KANSAS CITY AREA TRANSPORTATION AUTHORITY

Invitation for Bids (IFB) #F23-5003-39A
Traction Power Substation – KC Streetcar Riverfront Extensions (Package 3)

ADDENDUM #2

Issue Date: February 7, 2023

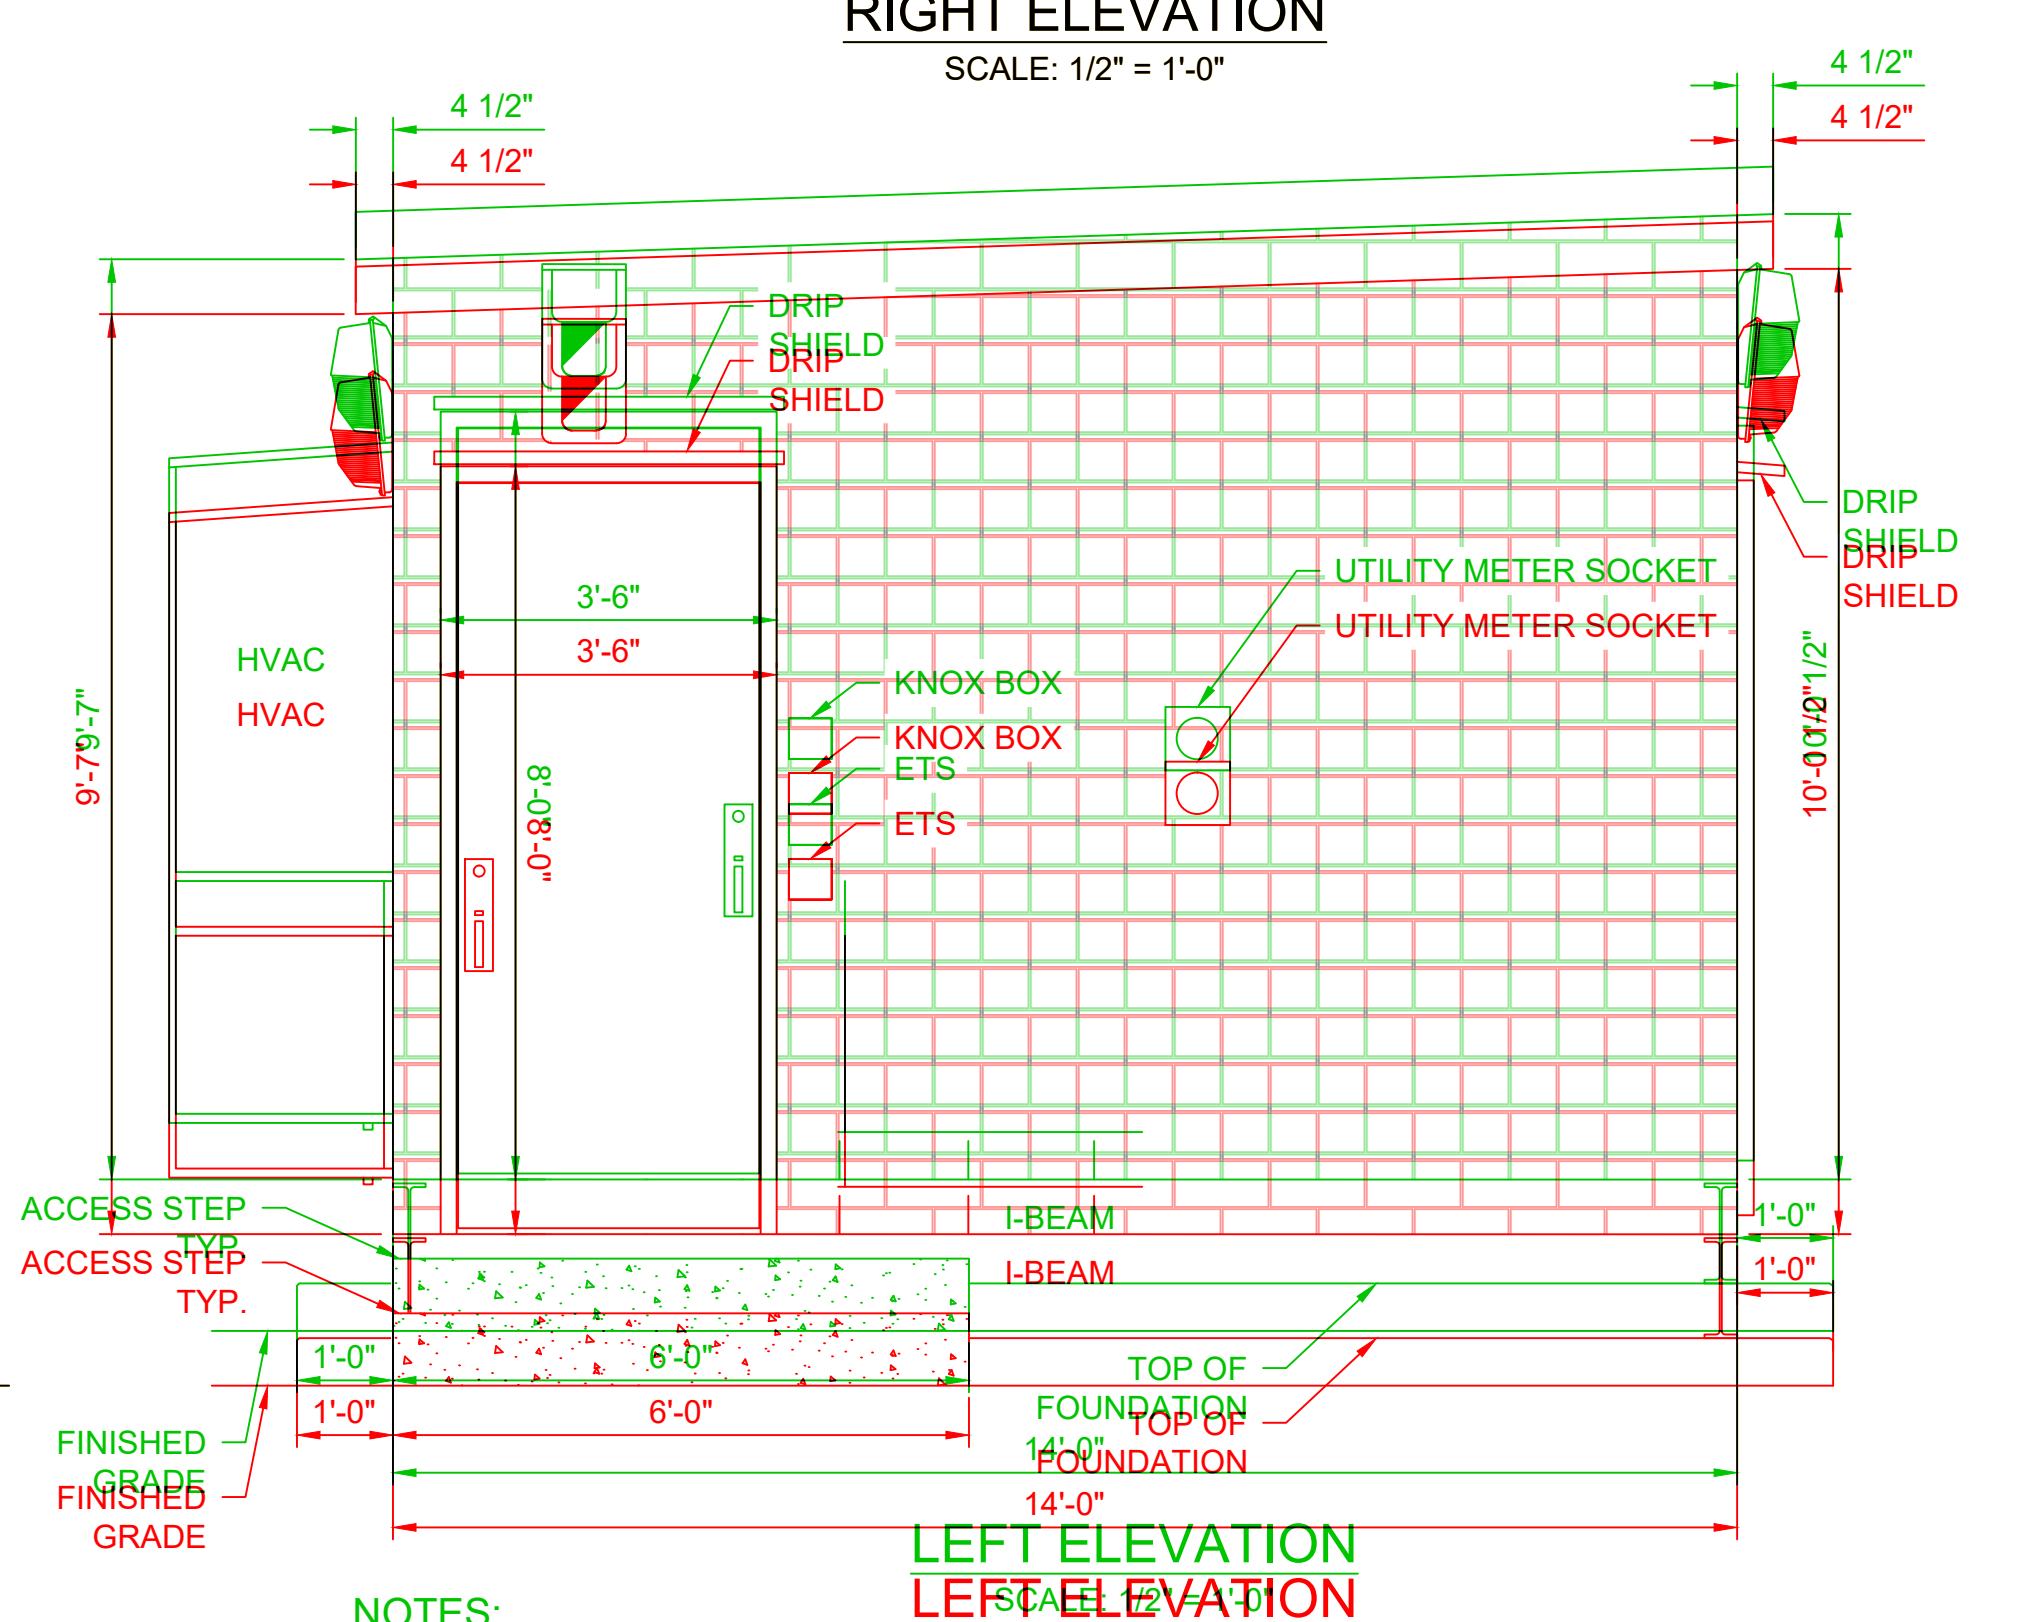
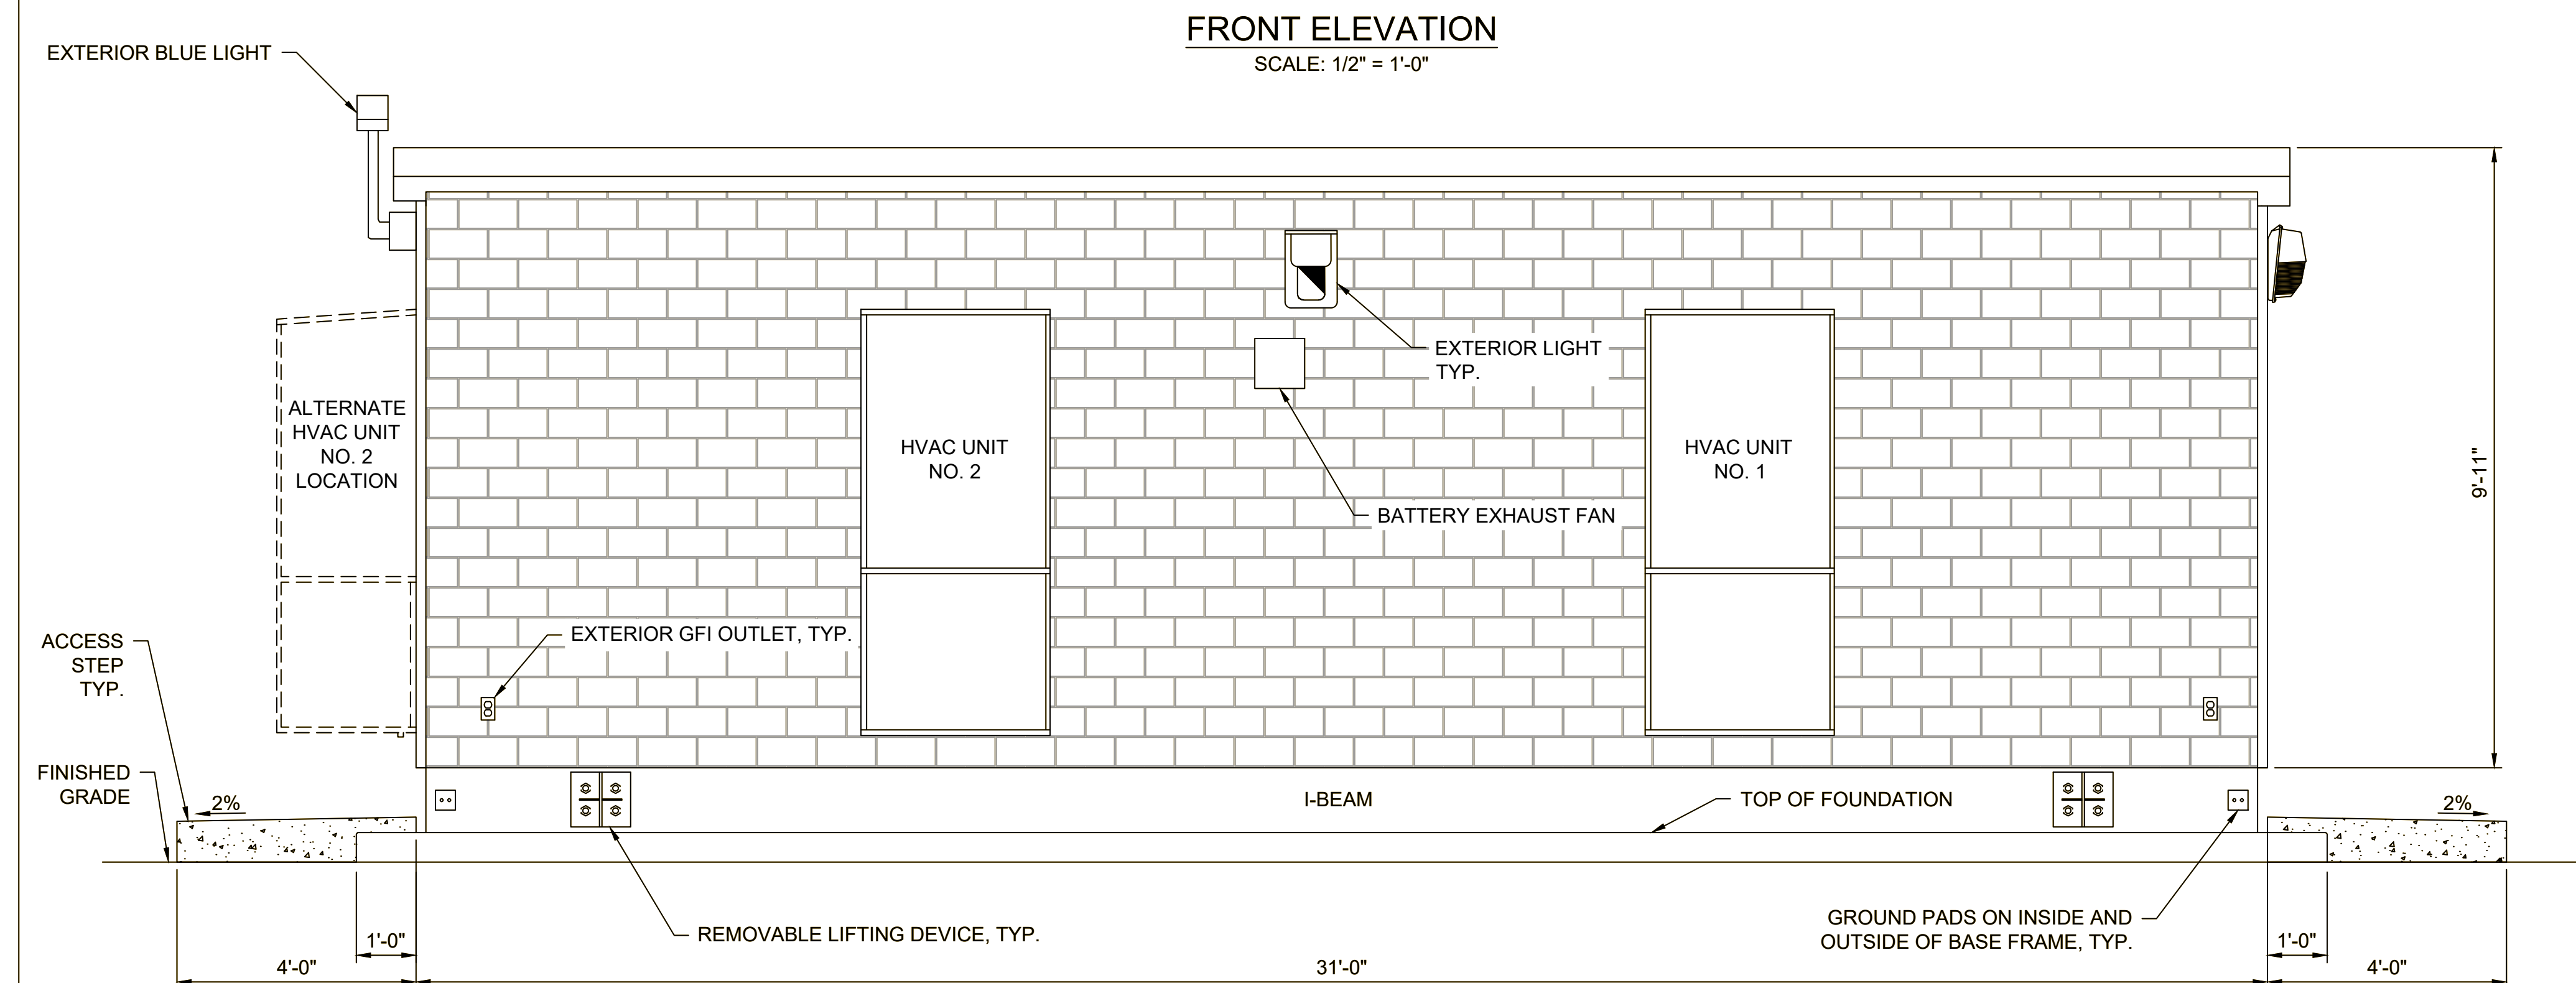
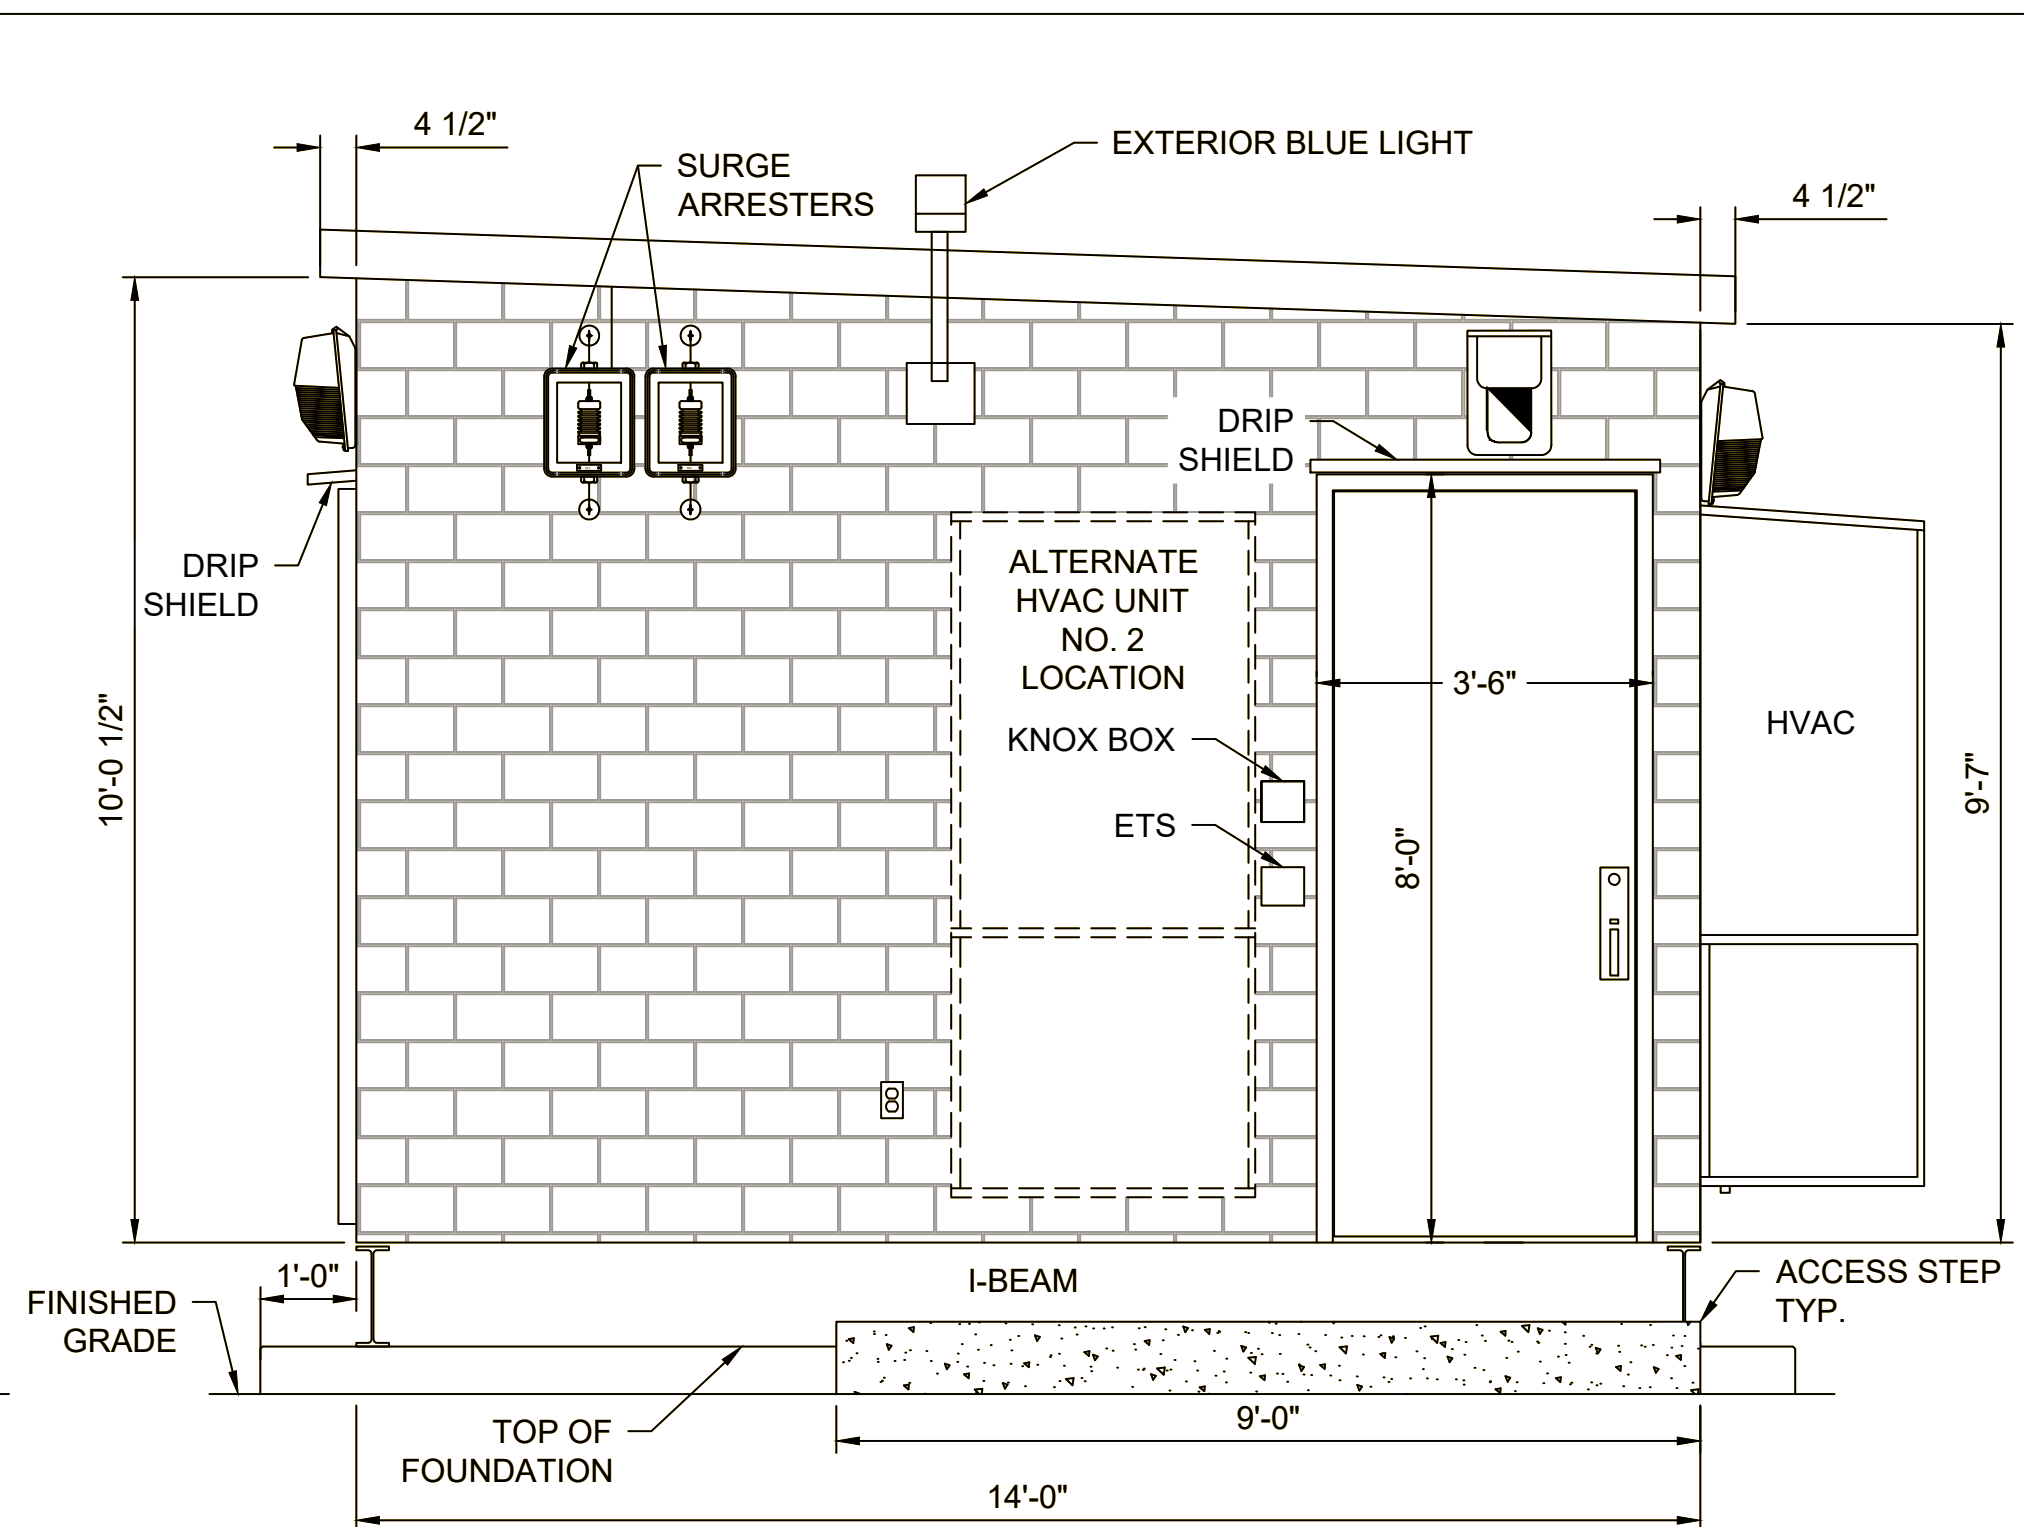
Red text and lines are the older version. Green text and lines are the updates. See updated BATES 304477 - 304504 for clean updated plan sheets.
